NSW PLANNING ASSESSMENT COMMISSION

21 September 2009

Report on the Proposed Jacfin Warehouse Project

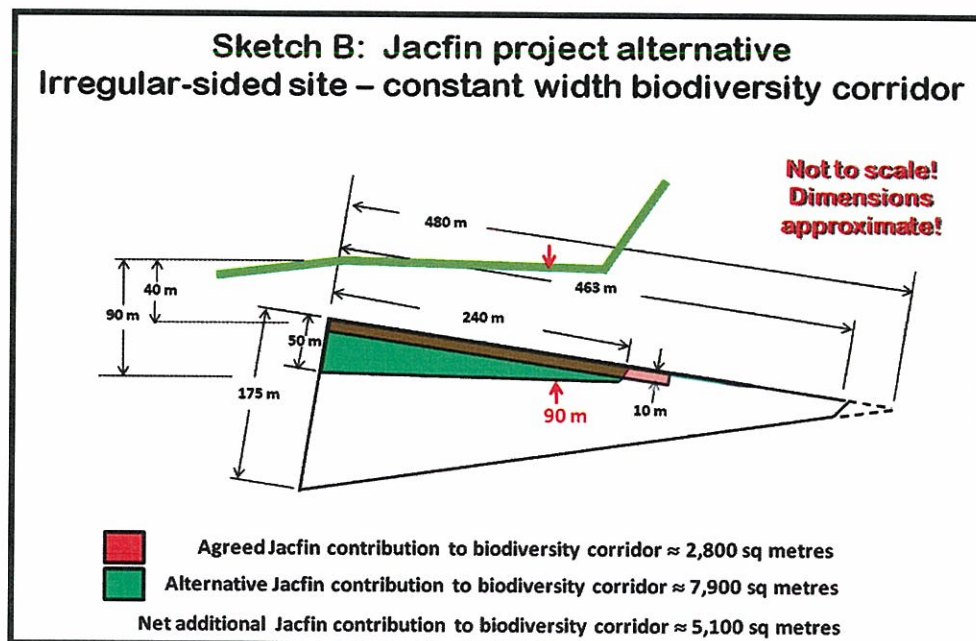
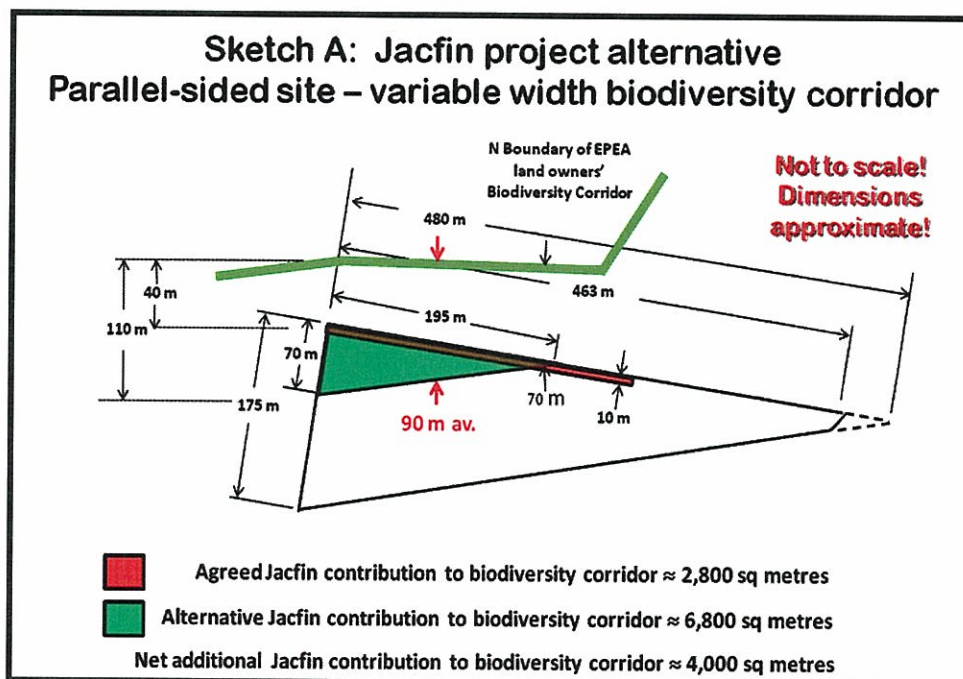
The Commission considers an alternative layout could take advantage of the triangular shape of the Jacfin site and enhance the biodiversity corridor, without requiring excessive sacrifice of developable land. In principle the triangular apex could be removed from the northern part of the site with the resultant shape becoming a four-sided figure, either an irregular trapezoidal shape or an irregular quadrilateral. This would enhance the corridor width in the most effective manner in terms of width-for-land-given-up.

The Commission has made some approximate calculations to demonstrate the concept, based on achieving an average width of 90m through the throat area of the biodiversity corridor as shown in sketches A and B. This alternative layout would require a re-design of the entrance to the site and the maneuvering apron to the west of the warehouse building. Arrangements for adequate passage of wildlife would also be needed. The presumption in this re-design would be that the 10m strip along the northern boundary would no longer be required as a contribution to the biodiversity corridors. This is estimated to have occupied about 0.28 ha.

If the layout resulted in a lot of developable land with parallel north and south sides (Sketch A), then the width of the corridor at the eastern entrance to the 'throat' would be about 70m and at the western entrance about 110m, with an average width of 90m. Allowing for the 'returned' 10m strip, the additional land Jacfin would need to give up to achieve this increase in corridor width would be 0.40 ha.

If the layout resulted in a biodiversity corridor with parallel sides (Sketch B), then the width of corridor would be 90m, the developable land would have an irregular quadrilateral shape. Allowing for the 'returned' 10m strip, the additional land Jacfin would need to give up to achieve this increase in corridor width would be 0.51 ha.

The Commission considers that re-design along these lines would represent a better compromise between conservation and development than the design as proposed.

- a biodiversity corridor which, taken together with committed land on adjacent properties, has an average width across the narrowest section adjacent to the Jacfin site (the 'throat') of at least 90m and a minimum width at any point of 70m;
